3B Containment Hydrodynamic Loads

The information in this appendix of the reference ABWR DCD, including all subsections, tables, and figures, is incorporated by reference with the following departures.

STD DEP 3B-2 (Table 3B-1, Figures 3B-12 and 3B-13)

Figure 3B-12 Time History of Air Bubble Pressure

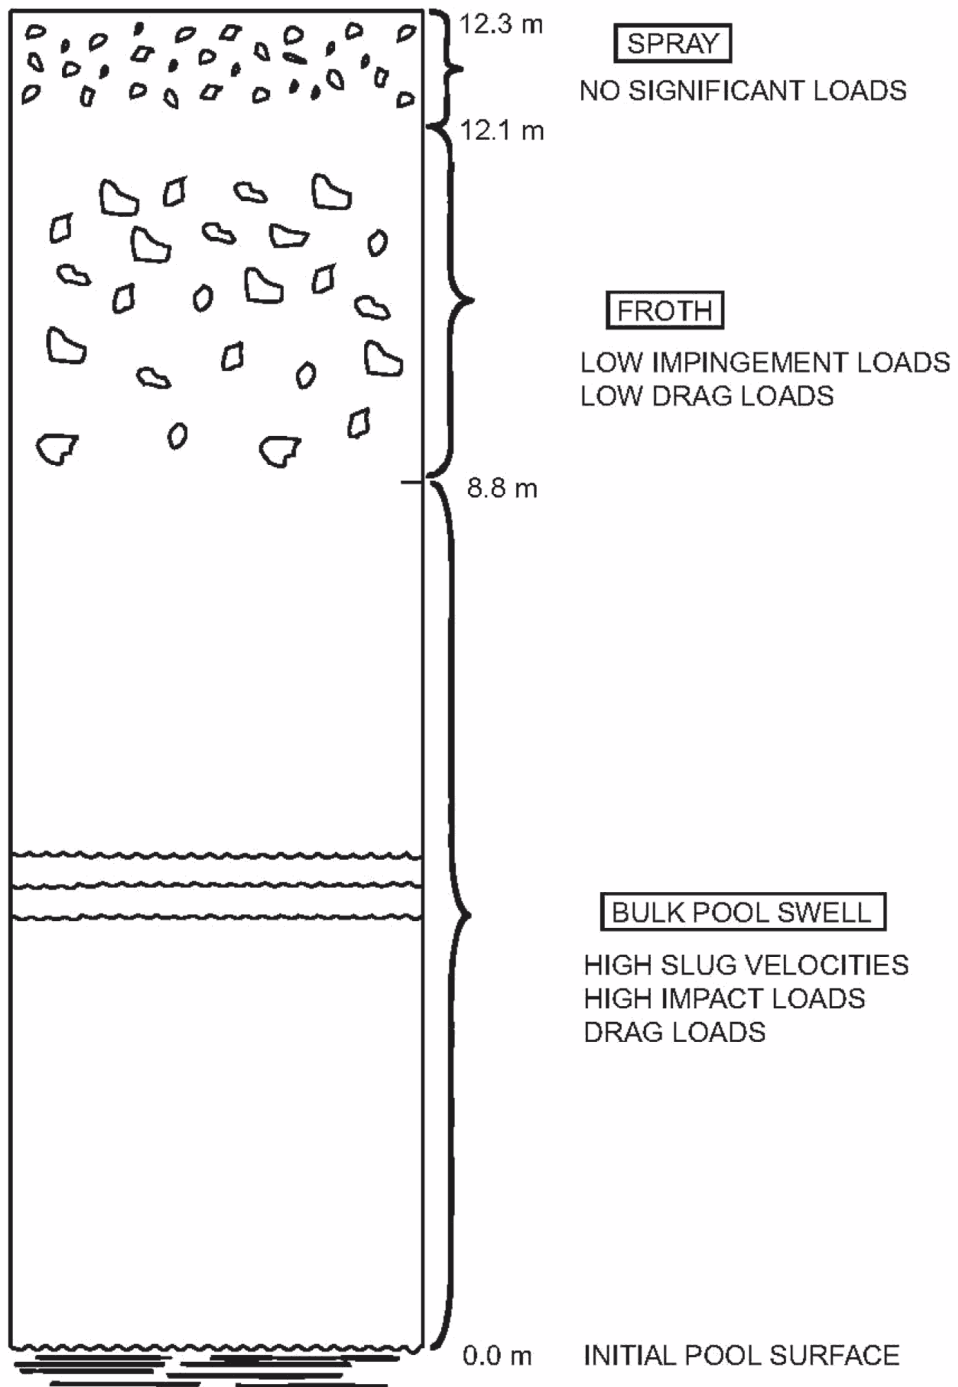
Description	Value
1. Air bubble pressure (maximum)	133.37 kPaG 195 kPaG
2. Pool swell velocity (maximum)	10.9 m/s
3. Wetwell airspace pressur (maximum)	107.87 kPaG 146 kPaG
4. Pool swell height (maximum)	7m 8.8m

Figure 3B-13 Schematic of the Pool Swell Phenomenon

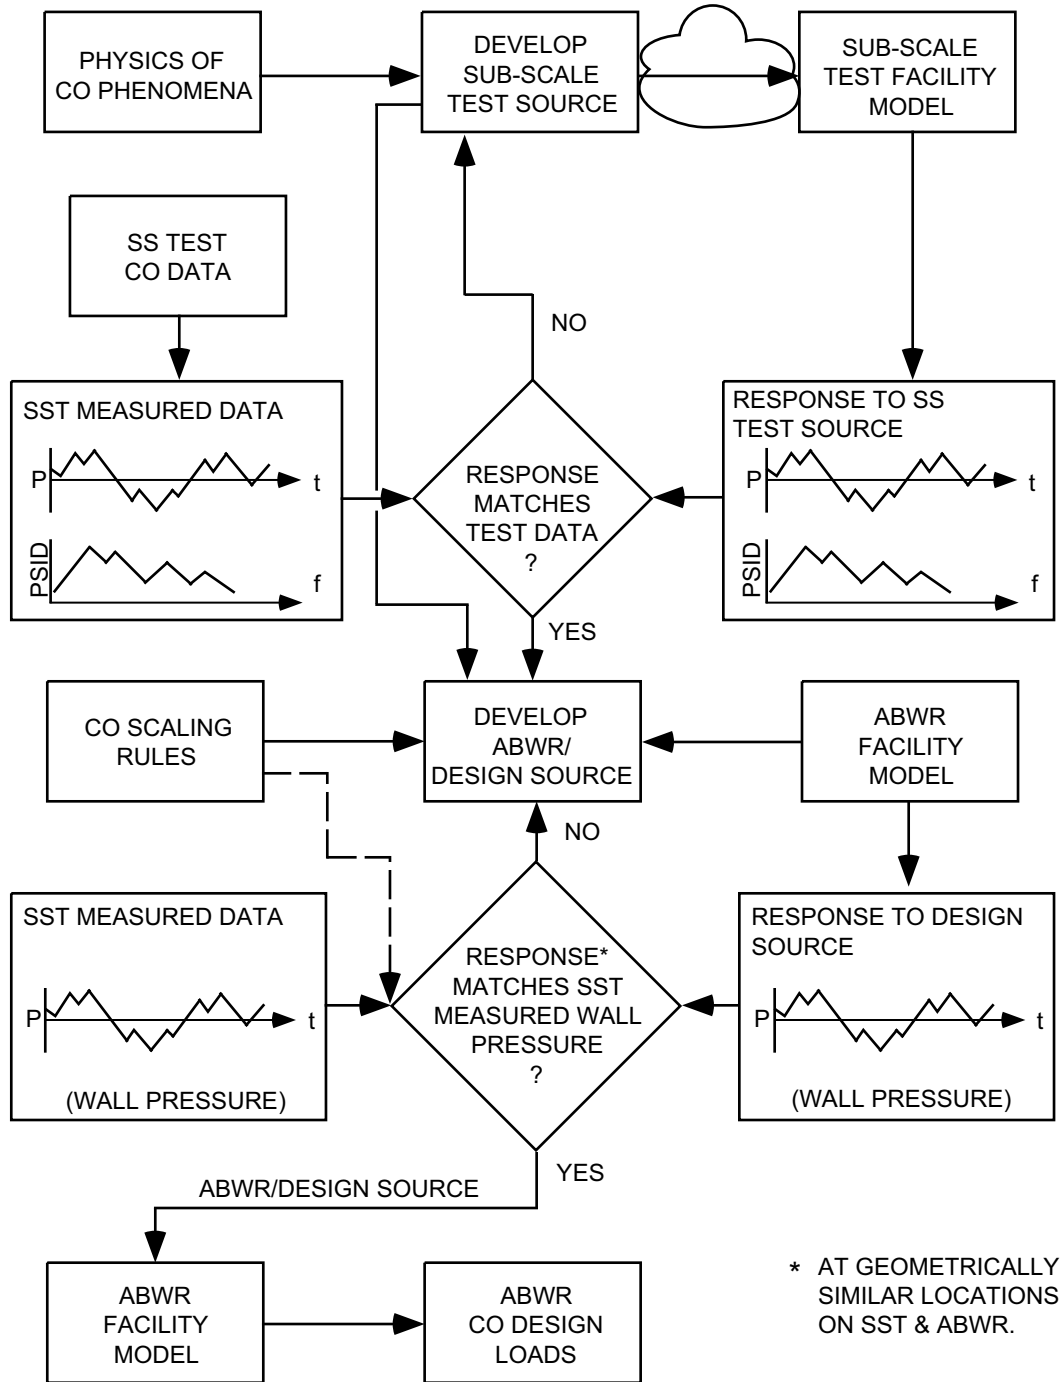
Structures located between 0 and ~~7m~~8.8m above the initial surface will be subjected to impact load by an intact water ligament, where the ~~7m~~8.8m value corresponds to the calculated maximum pool swell height. The load calculation methodology will be based on that approved for Mark II and Mark III containments (NUREG-0487 and NUREG-0978).

Structures located at elevations between the ~~7m~~8.8m and ~~40.3m~~12.1m will be subjected to froth impact loading. This is based on the assumption that bubble breakthrough (i.e., where the air bubbles penetrate the rising pool surface) occurs at ~~7m~~8.8m height, and the resulting froth swells to a height of 3.3m. ~~This froth swell height is the same as that defined for Mark III containment design and this.~~ This is considered to be conservative for the ABWR design. Because of substantially smaller wetwell gas space volume (about 1/5th of the Mark III design), the ABWR containment is expected to experience a froth swell height substantially lower than the Mark III design. The wetwell gas space is compressed by the rising liquid slug during pool swell, and the resulting increase in the wetwell gas space pressure will decelerate the liquid slug before the bubble break-through process begins. The load calculation methodology will be based on that approved for the Mark III containment (NUREG-0978).

As shown in Figure 3B-13 the gas space above the ~~40.3 m~~12.1m elevation will be exposed to spray condition ~~including~~ which is expected to induce no significant loads on structures in that region.
